Form 3160-5
(June 2019)UNITED STATES
DEPARTMENT OF THE INTERIOR
BUREAU OF LAND MANAGEMENTFORM APPROVED
OMB No. 1004-0137
Expires: October 31, 2021**SUNDRY NOTICES AND REPORTS ON WELLS**
Do not use this form for proposals to drill or to re-enter an abandoned well. Use Form 3160-3 (APD) for such proposals.

8. Well Name and No. DILLON 31 FED COM/703H

EOG respectfully requests an amendment to our approved APD for this well to reflect the following changes:

**Dillon 31 Fed Com 505H****Revised Permit Information 07/18/2022:**

WELL LOCATION AND ACREAGE DEDICATION PLAT

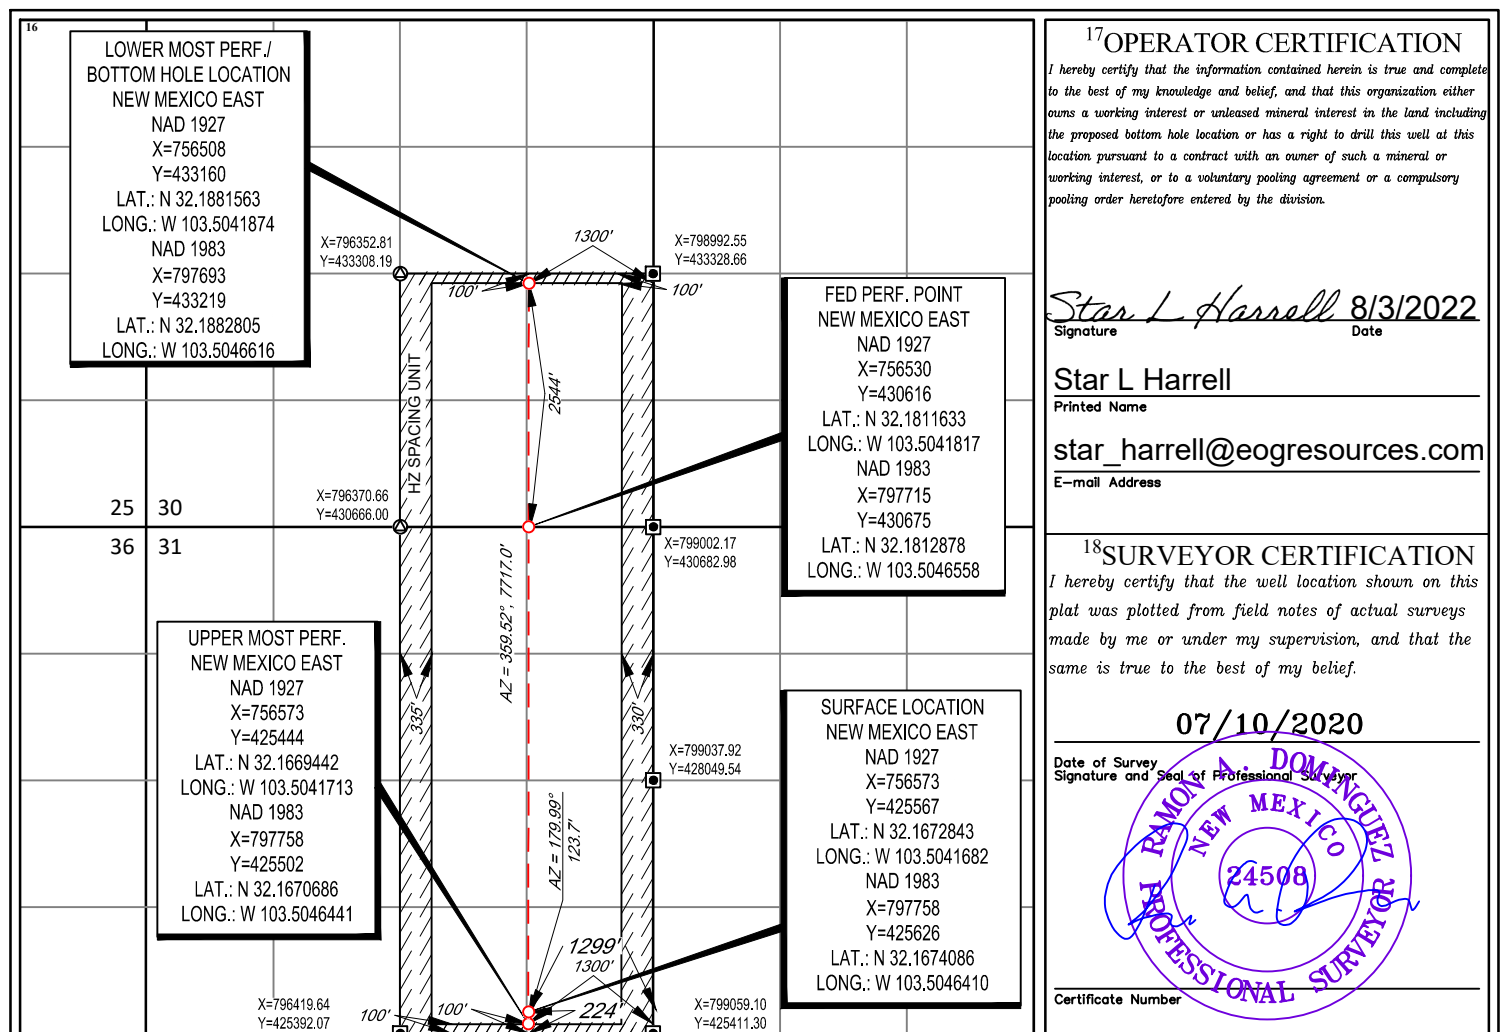
Change name from 703H to Dillon 31 Fed Com 505H.

Change SHL from T-24-S, R-34-E, Sec 31, 284' FSL, 1140' FEL, Lea Co., NM, to T-24-S, R-34-E, Sec 31, 224' FSL, 1299' FEL, Lea Co., N.M.

Change BHL from T-24-S, R-34-E, Sec 30, 2544' FSL, 1590' FEL, Lea Co., NM, to T-24-S, R-34-E, Sec 30, 2544' FSL, 1300' FEL, Lea Co., N.M.

UL or lot no.	Section	Township	Range	Lot Idn	Feet from the	North/South line	Feet from the	East/West line	County
P	31	24-S	34-E	-	224'	SOUTH	1299'	EAST	LEA

UL or lot no.	Section	Township	Range	Lot Idn	Feet from the	North/South line	Feet from the	East/West line	County
I	30	24-S	34-E	-	2544'	SOUTH	1300'	EAST	LEA
